MEMORANDUM

SUBJECT: Huxley Envelope Industrial Site (C224147)
Minor Change to the Decision Document

To:	Brian Davidson	From:	Marc Godick
Company:	NYSDEC – Division of Environmental Remediation	Date:	3/3/15
Address:	625 Broadway	Phone No.:	914-922-2356
	Albany, NY 12233	Total Pages (incl. cover):	3
Phone No.:	518-402-9790	Job Number:	11884
Subject:	Proposed Modification to Decision Document (BCP Site No C224147)		
	145/155 West Street, Greenpoint, Brooklyn, Kings County, New York

SITE PLAN WITH ALPHANUMERIC GRID
AND SOIL SAMPLING SUMMARY

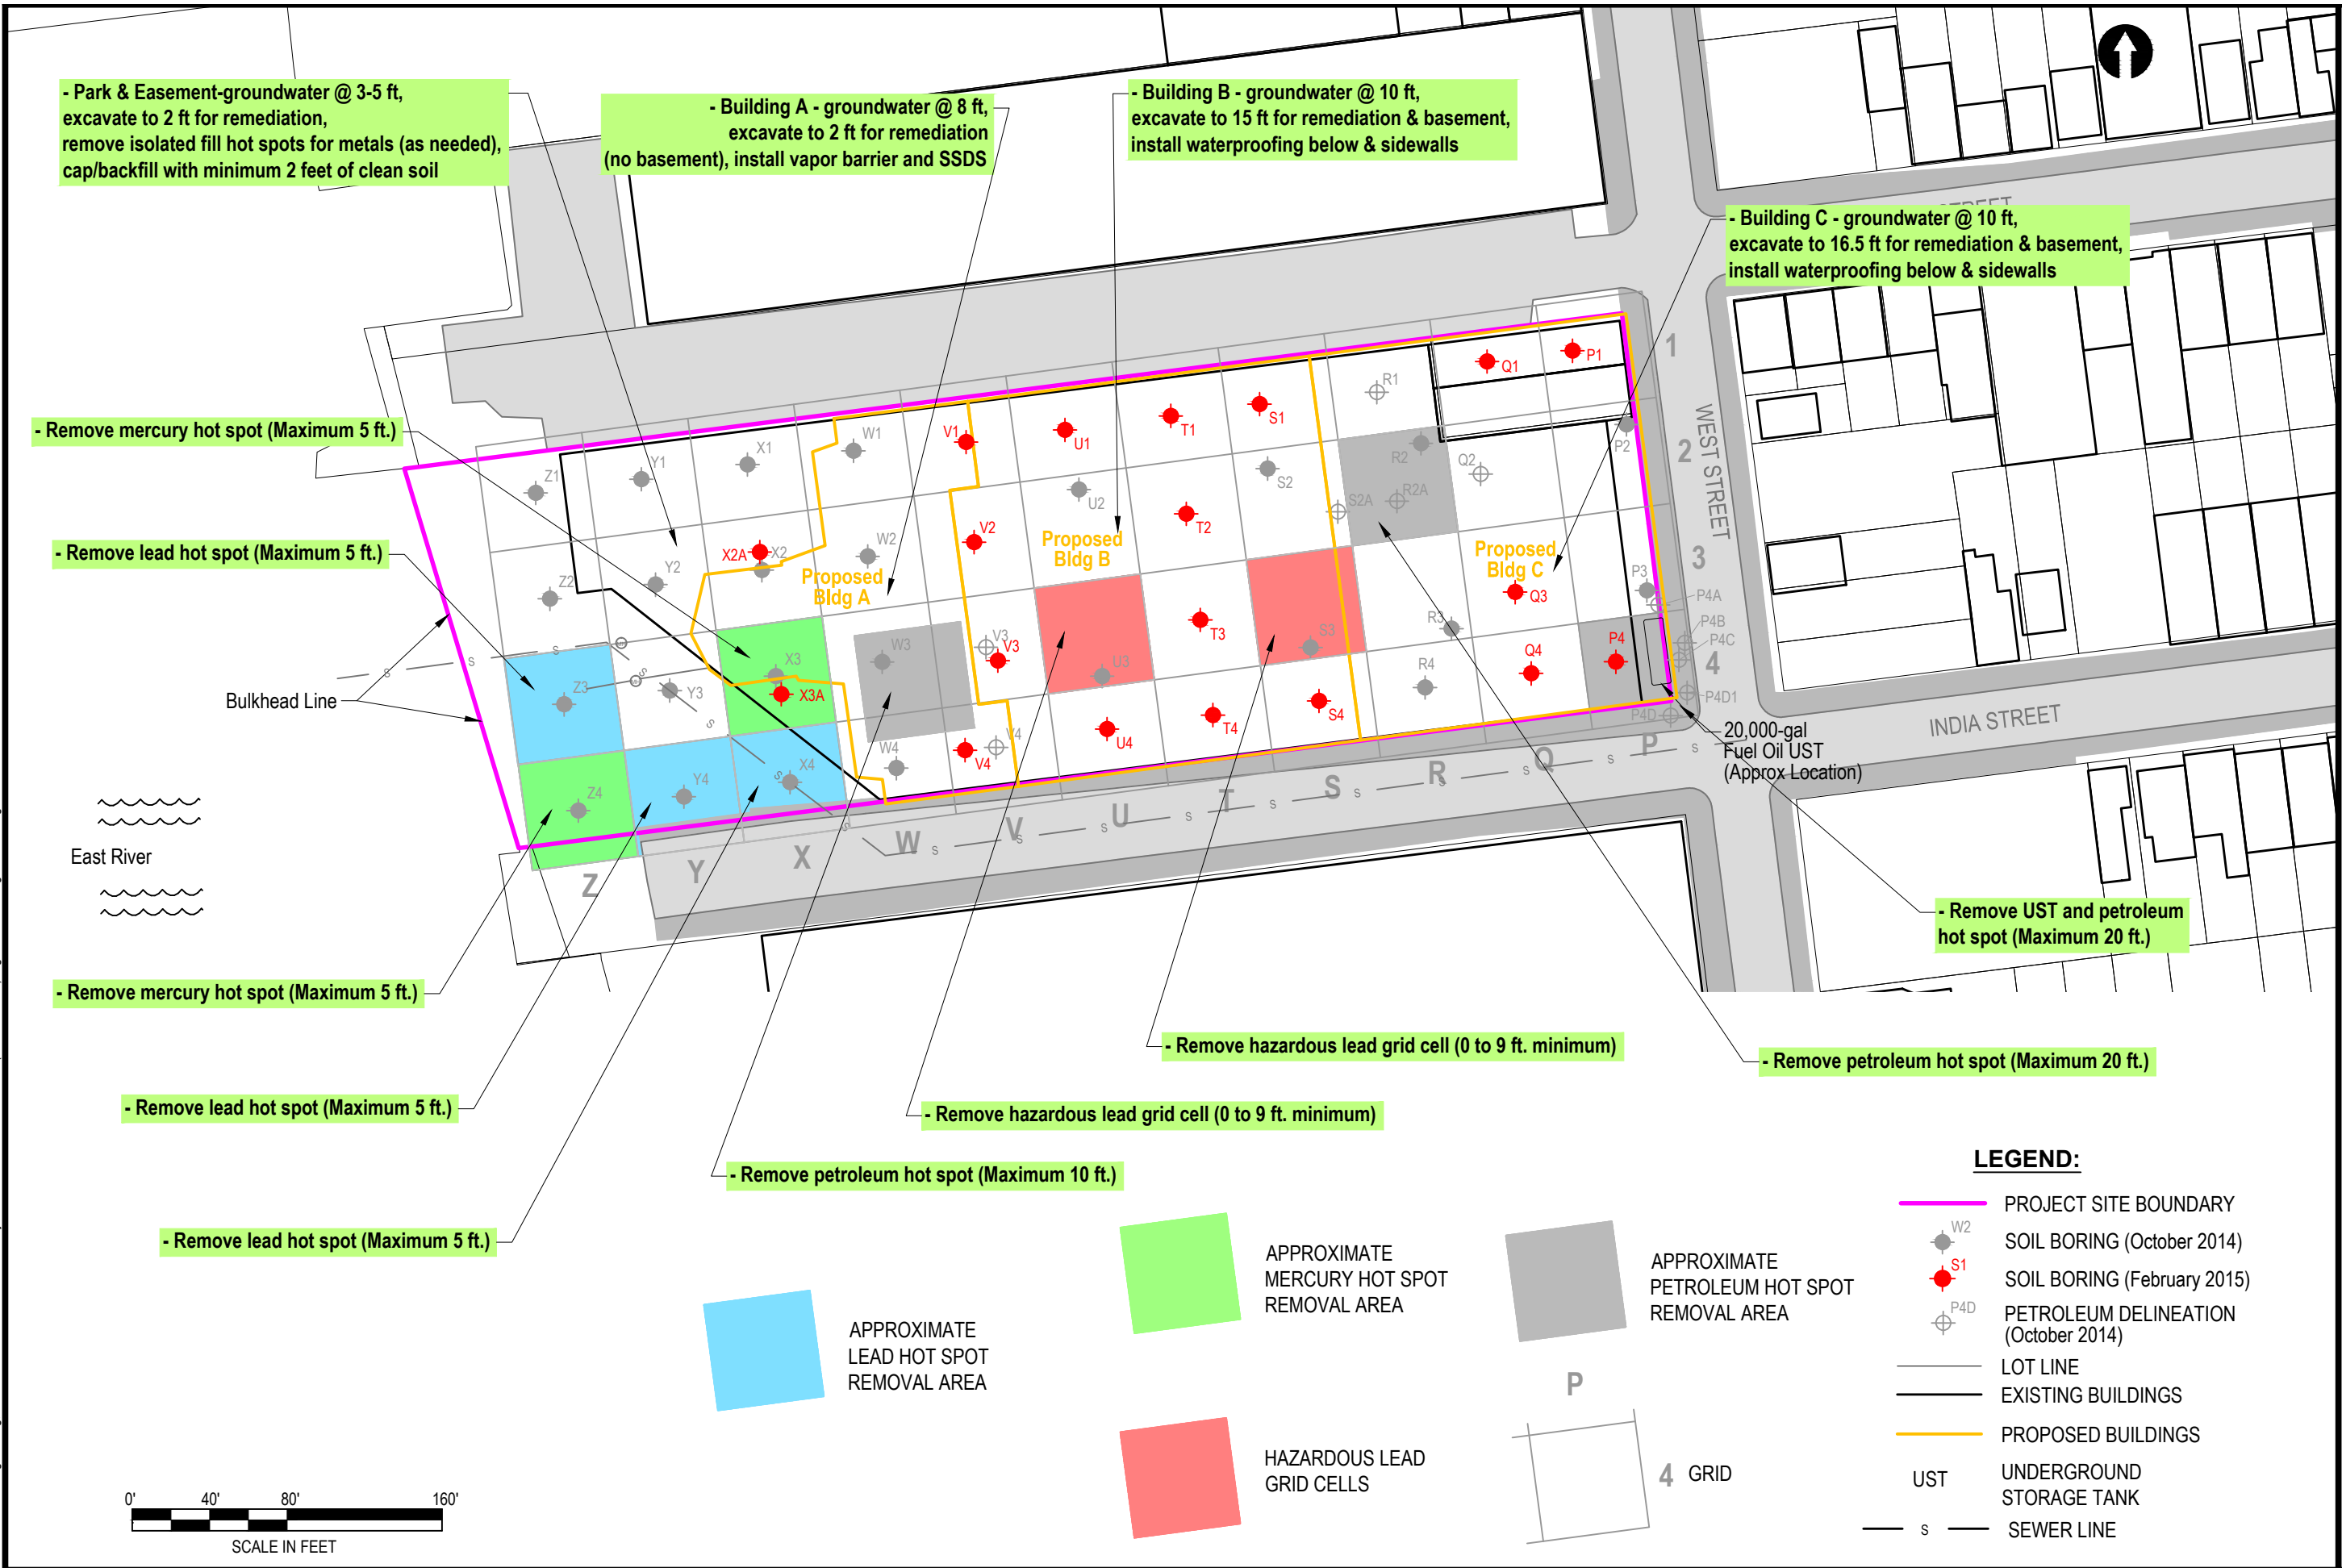
The redevelopment plan for this site has three areas associated with three proposed buildings (Buildings A, B and C, see attached figure). The site in the areas of proposed Buildings B and C would achieve at least a Track 2 cleanup (the area of Building C may achieve Track 1) as these areas would be excavated to approximately 15 feet (with the excavation extending to greater depths for any hot spots/source material). As a result, for the areas of Buildings B and C there would be no change to the March 2014 Decision Document since at least a Track 2 remedy will be achieved.

For the area of proposed Building A and the Park/Esplanade/ Easement area the Decision Document will be changed to allow for the following modification to the remedy. The area of Building A is located closest to the East River; the remedy has been modified to avoid deep excavations in this area which would result in the need for extensive dewatering due to the proximity of this area of the site to the East River. The excavation in this area and in the Park/Esplanade/Easement area would be to a depth of two feet, with the excavation extending deeper to address any hot spots/source material. Therefore remediation in the area of Building A and the Park/Esplanade/ Easement area would achieve a Track 4 restricted residential soil cleanup which would include a cover system of two feet of soil meeting restricted residential soil cleanup objectives anywhere that wasn't covered by components of the development (building, pavement, etc.). In these areas the contingent environmental easement and Site Management Plan will be required.

The modified remedy is shown on the attached figure.

The Building C parcel as depicted on the attached schematic Figure A will be excavated to a depth of approximately 16.5 feet below grade with the remedial goal of achieving a Track 1 Cleanup. In addition, two petroleum hot spots will be excavated to a maximum anticipated depth of 20 feet below grade. Groundwater is present at a depth of approximately 10 feet below grade. In the event that end-point samples do not meet the Track 1 cleanup standards, a Track 2 Cleanup will be achieved since excavation will be completed beyond 15 feet below grade and hot spots will be removed.

The Building B parcel will be excavated to a depth of approximately 15 feet below grade with the remedial goal of achieving a Track 2 Cleanup. Groundwater is present at a depth of approximately 10 feet below grade.

Due to the shallow water table (depth of approximately 5 feet below grade) and proximity to the East River, the Building A Parcel will be excavated to a depth of 2 feet and the grade will then be raised greater than 2 feet with suitable backfill material pursuant to the Part 375 regulations for a pile-supported foundation. In addition, one petroleum hot spot will be excavated to a maximum depth of 10 feet below grade, which excavation depth is anticipated to achieve hot spot removal. A remedial goal of a Track 4 Cleanup will be achieved for Building A.

As anticipated in the current Decision Document, the Park/Easement Area (between Building A and the bulkhead) will be excavated to a depth of 2 feet below grade and capped with a minimum of 2 feet of clean soil, for the purpose of achieving a remedial goal of a Track 4 Cleanup. In addition, additional hot spots would be excavated to address elevated metals in fill to maximum depths of 4 to 5 feet below grade, but no excavation below the water table.

A schematic (Figure A) depicting the buildings/areas, proposed excavation depths, depth to water, and hot spots is attached.
